Subject: Alteration to Sta. 33.06 Rib Assembly on PA-24 Series Aircraft

Reference: "Modification to Rib Assembly PA-30 Sta. 33.06", Hans D. Neubert,
FAA DER NM-536, dated 1 September 1988.

**Report Number
HDN-01-090188**

**Modification to Rib Assembly
PA-24/PA-30 Aircraft
Wing Station 33.06**

INBOARD RIB PROFILE AT STATION 33.06
(MODIFIED)

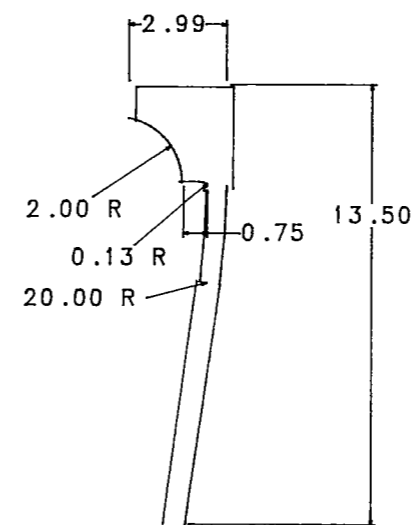
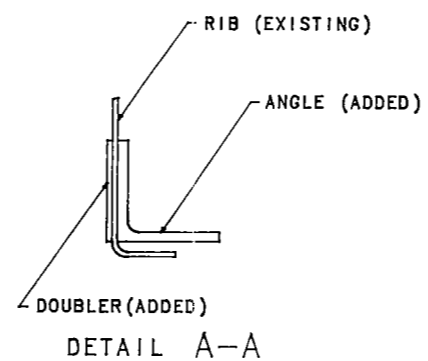
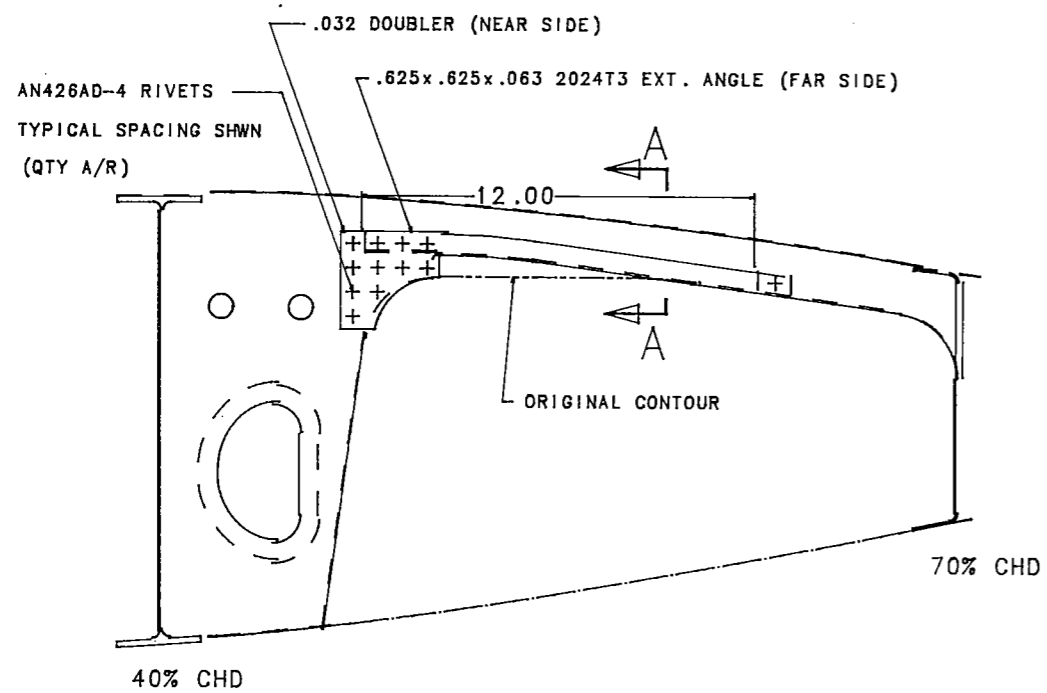
I have reviewed the design configuration and analysis in the subject report and find that this alteration performed on the PA-30 series aircraft is also applicable to the PA-24 single engine Comanche series aircraft. I recommend approval of this alteration when performed to the specifications found in the reference report.
